**RE: Addendum to Lauzon Parkway Improvements Environmental Study Report
Notice of Filing of Addendum
Our File: W.O. 3214032**

LAUZON PARKWAY IMPROVEMENTS

ADDENDUM

May 19, 2015

EXHIBIT 16: TYPICAL 4-LANE CROSS-SECTION BETWEEN WALKER ROAD AND EAST OF THE MID-BLOCK ROUNDABOUT

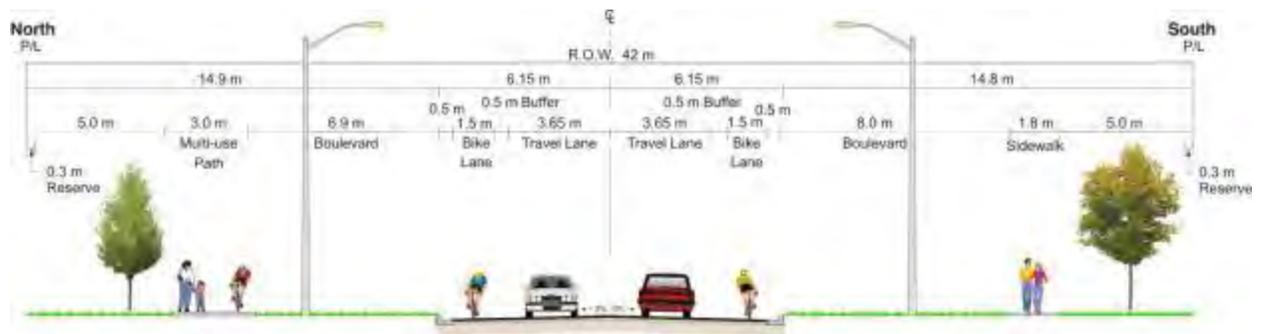
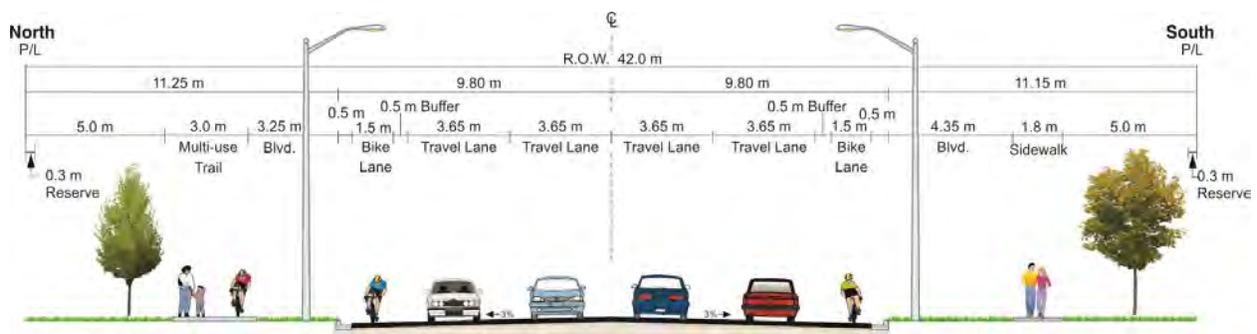
As noted in Section 2.1, the E-W Arterial was originally recommended as a 2-lane roadway, with the ROW protection for a future 4-lane cross-section. Due to the WCF access roundabout being shifted closer to the CN rail line, it is recommended that the E-W Arterial will be built with 4-lanes from Walker Road to east of the mid-block roundabout.

The revised cross-section for E-W Arterial between Walker Road and the mid-block roundabout is illustrated in Exhibit 16.

Should Alternative 5 be implemented, the 4-lane cross-section would only be required in the vicinity of the Mid-Block roundabout and at the Walker Road intersection.

EXHIBIT 12: WCF ACCESS LOCATION FOR ALTERNATIVE 4

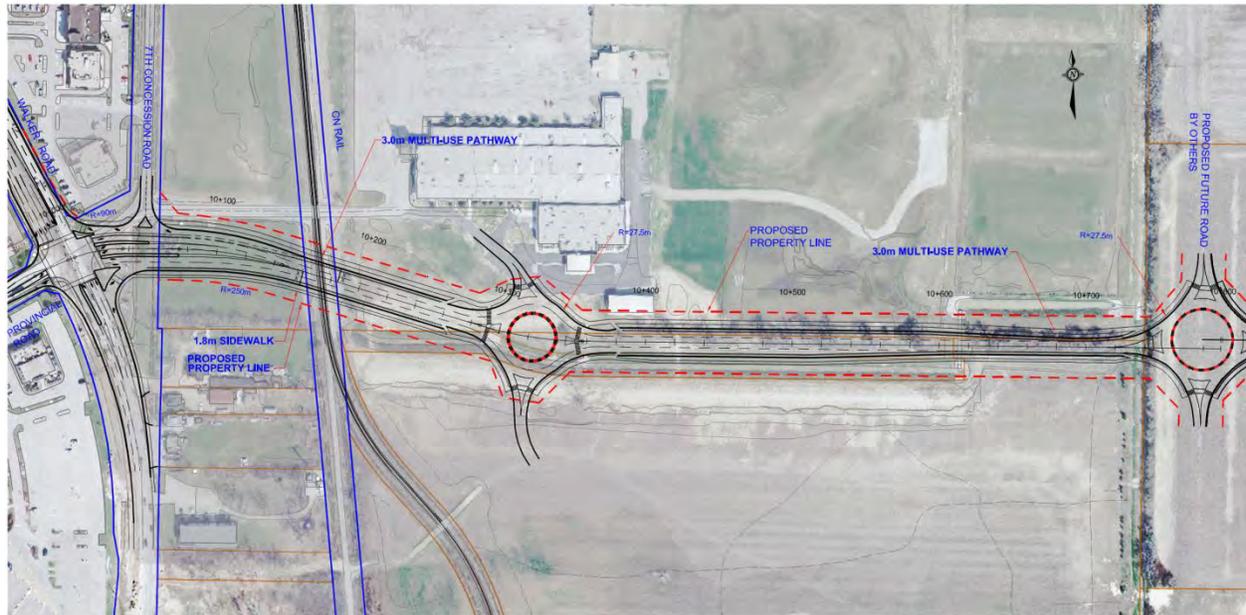
- **Alternative 4:** 4-lane E-W Arterial with the recommended EA Mid-Block roundabout (modified with 2 lanes) shifted west approximately 100 m (approximately 120 m east of CN Rail line)

Alternative 4 is preferred as it provides good access to all properties, meets geometric standards with respect to distance to adjacent intersections, provides sufficient on-site storage, provides sufficient storage between the railway crossing and the WCF access, limits the number of direct accesses to the controlled access arterial reducing driver demand, and results in minimal added costs. However, as Alternative 4 still represents an inherent risk based on the agreed project assumptions, if these assumptions are not met, then Alternative 5 would be preferred.

PLATE
1
 EXHIBIT 17

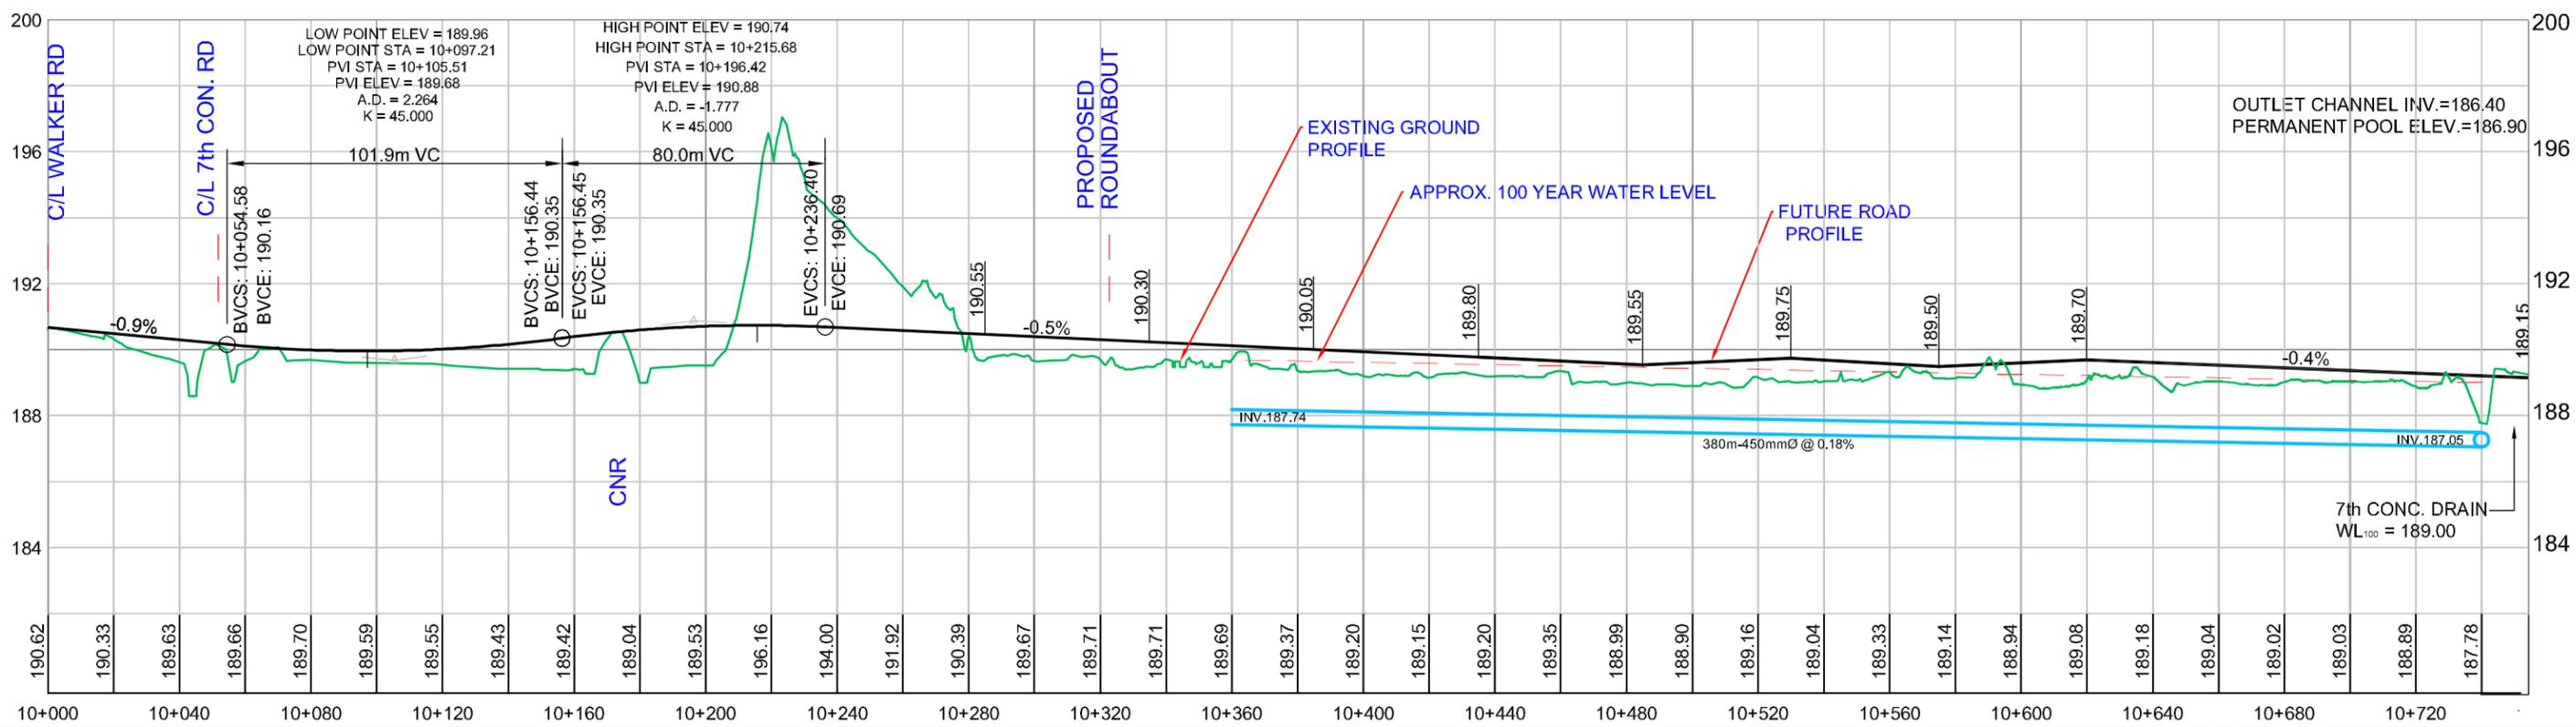
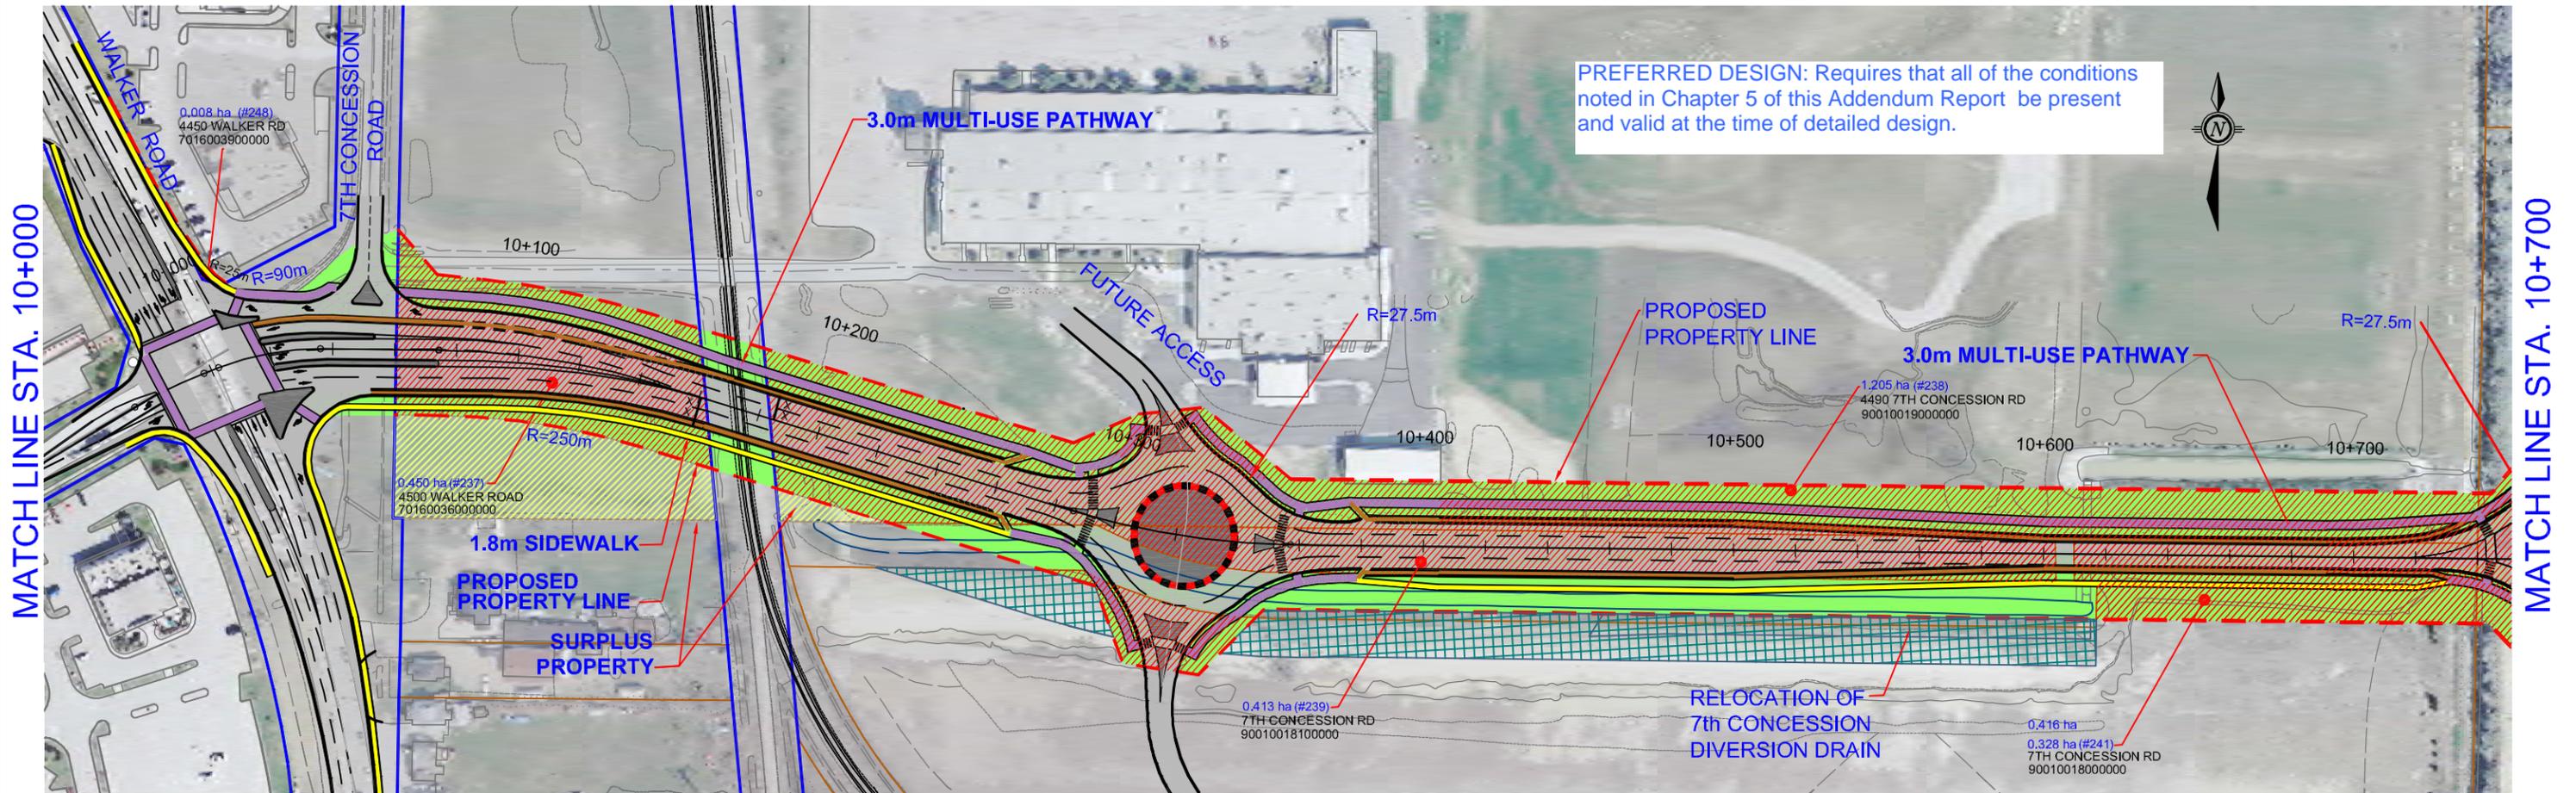
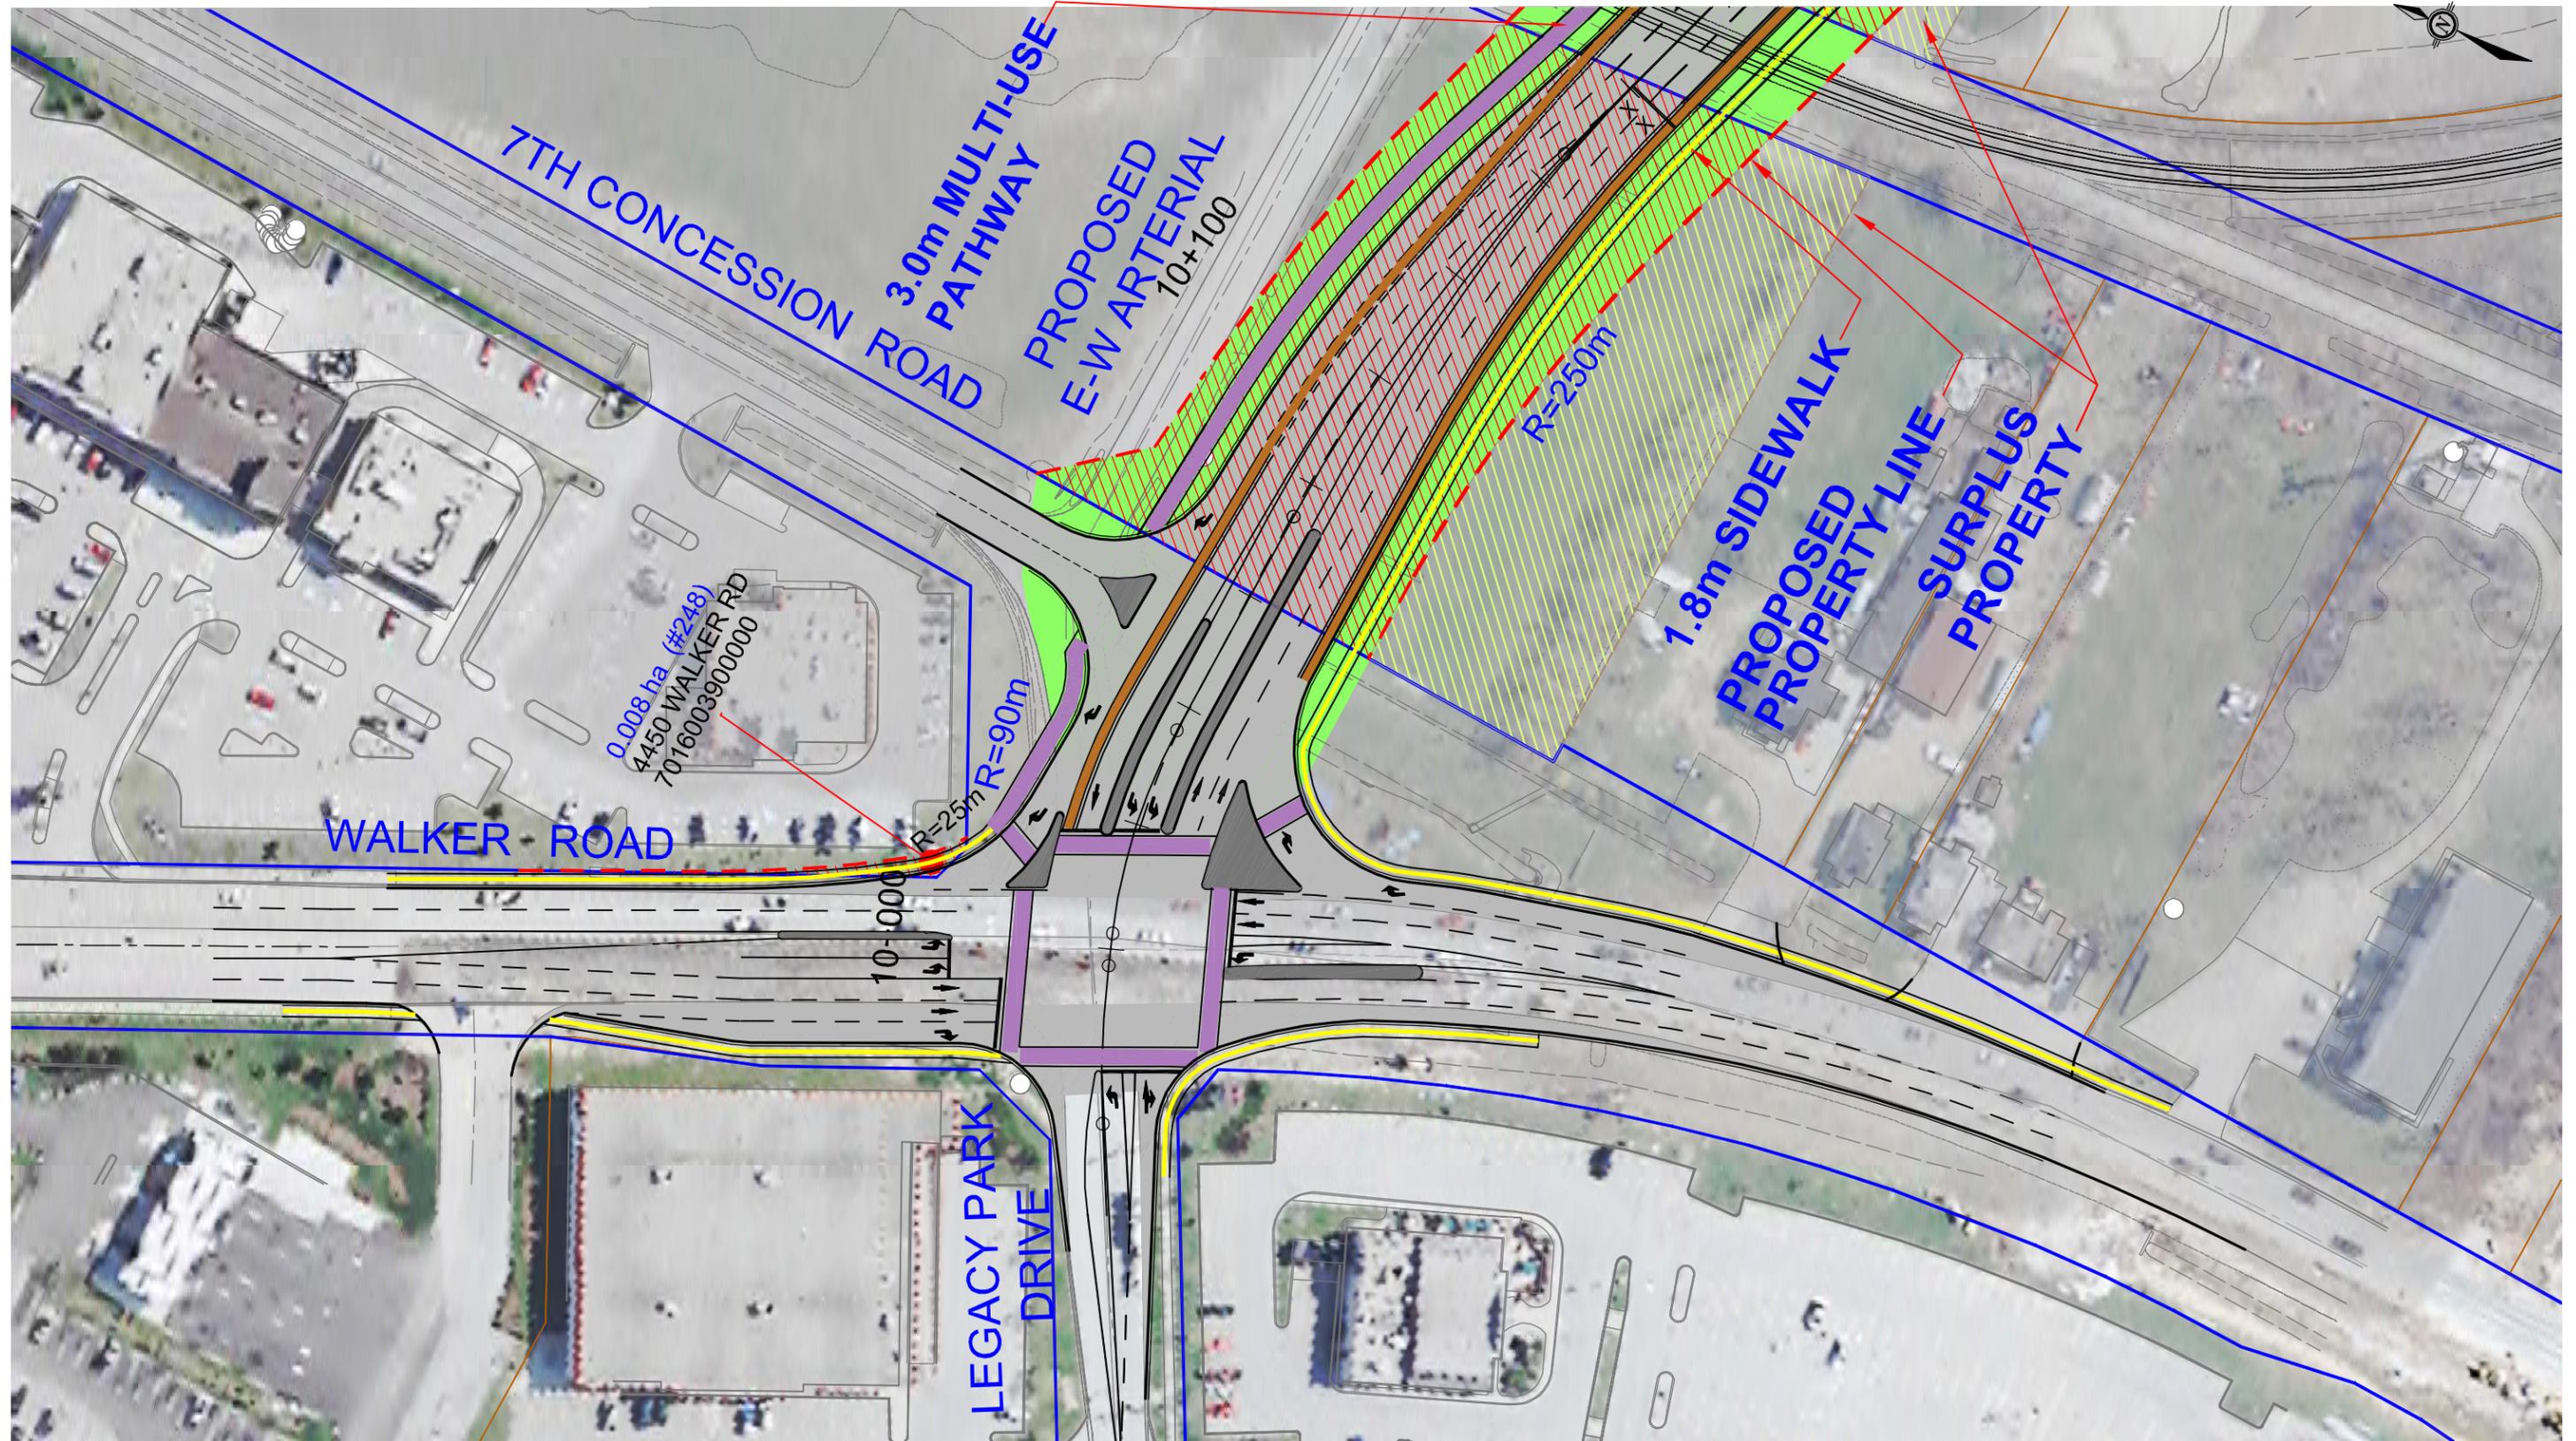
The Recommended Plan and profile is shown on Plates 1, 1a, and 2 in Exhibit 17.

Exhibit 17 illustrates the plan view of the E-W Arterial as provided in the Lauzon Parkway Improvements ESR - Plate 1, with a mid-block roundabout between Walker Road and the proposed East Pelton N-S Collector Road.
